Allied Paper, Inc./Portage Creek/Kalamazoo River Superfund Site
Willow Boulevard/A-Site Landfill Operable Unit 2 Preliminary Design Report -
Addendum 1 – Responses to USEPA/MDNRE Draft Comments

As requested by USEPA, these responses are to be considered as Addendum 1 to the July 2010 Preliminary Design Report.

BERM SECTION - OPTION 2

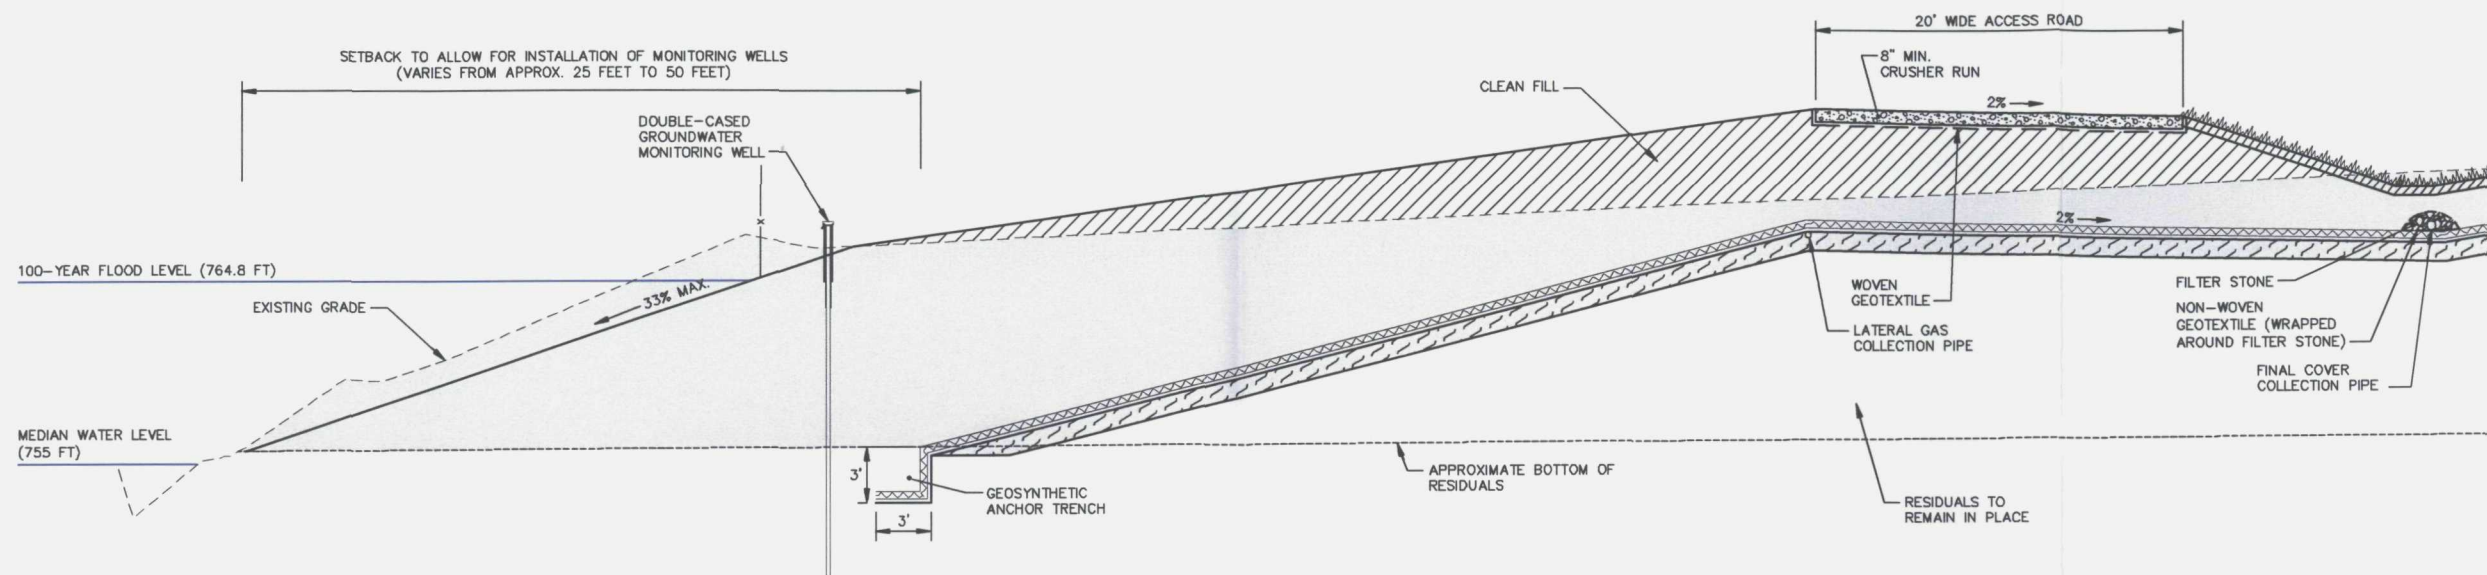
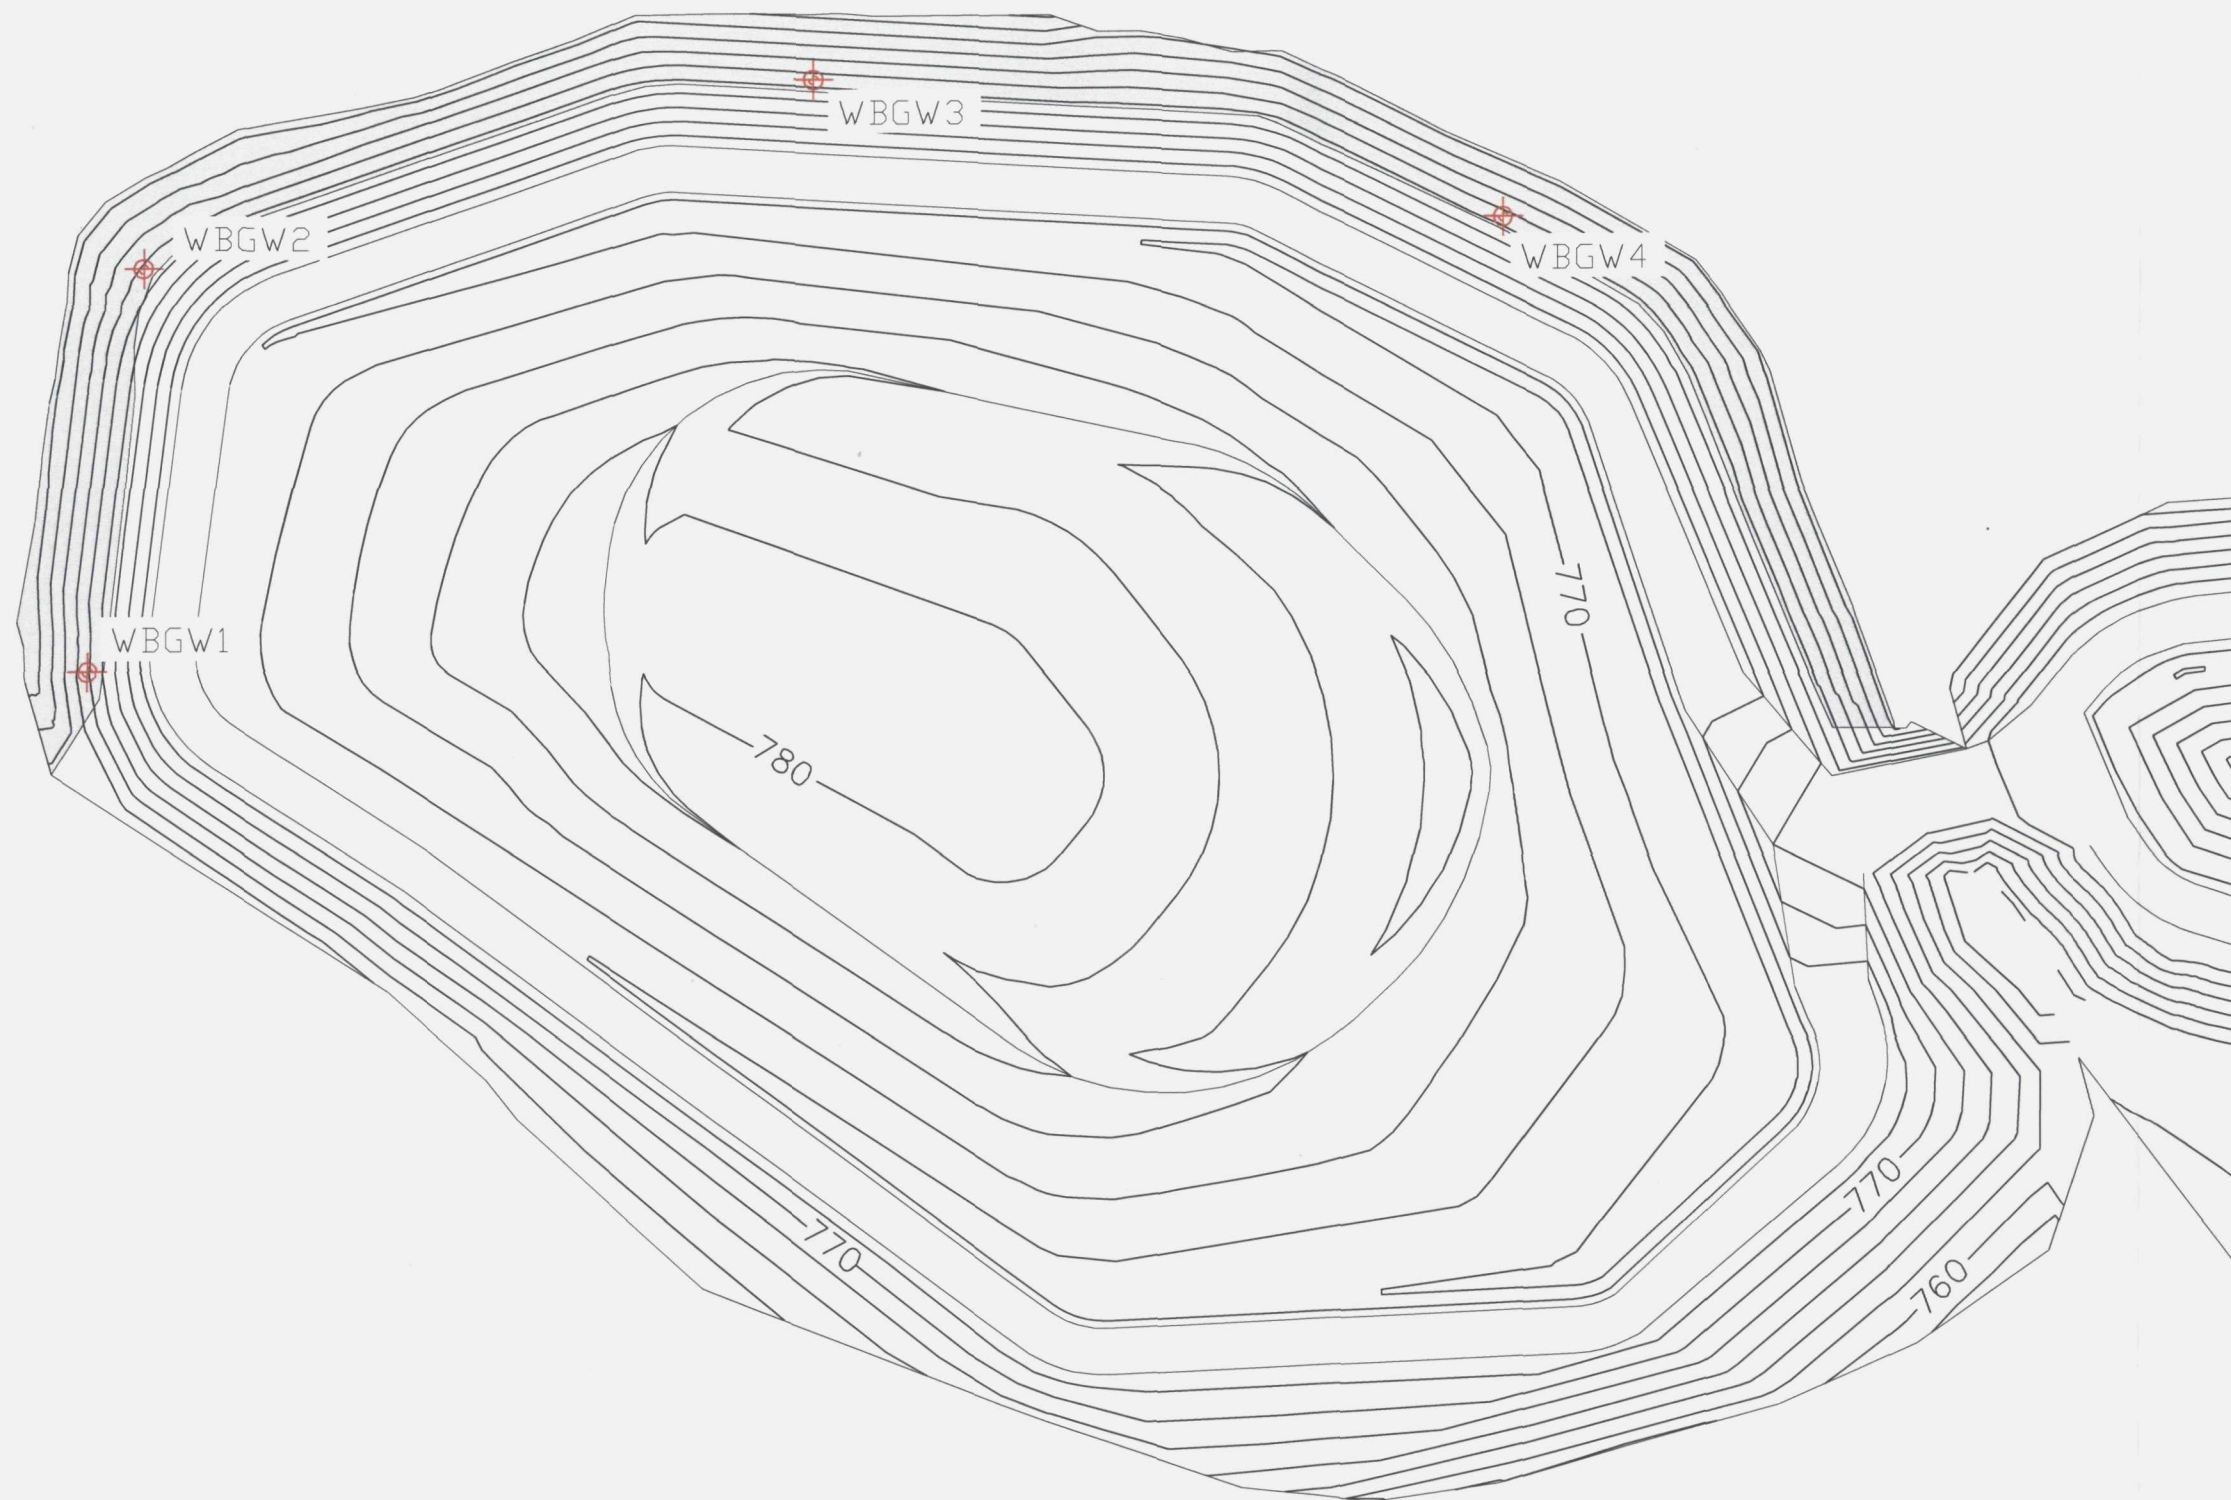
MDNRE Comment 2:

- Excavation back from the shoreline by varying distances along the perimeter of the Willow Boulevard Landfill, and backfilling to achieve a 3:1 slope to the top of berm (in this option the cover system would continue down the backslope of the excavated residuals at a slope of 25% to the bottom of excavation). As with the previous option, the groundwater monitoring wells would be moved downslope to minimize excavation. A conceptual cross section for this option is provided in Figure 6 and Figure 7 shows a plan view of the monitoring well locations and extent of excavation. It is estimated that this option would result in the excavation of an additional 12,100 cy of material (in addition to the 6,500 cy already accounted for in the Preliminary Design), which may have schedule implications for the project. Similar to the localized excavation option, the existing groundwater flow paths may be altered, excavation may need to be performed down below the water table (thus raising issues of mixing between impacted and non-impacted materials), and there would be an increased need to manage and control river water, stormwater, and/or leachate.
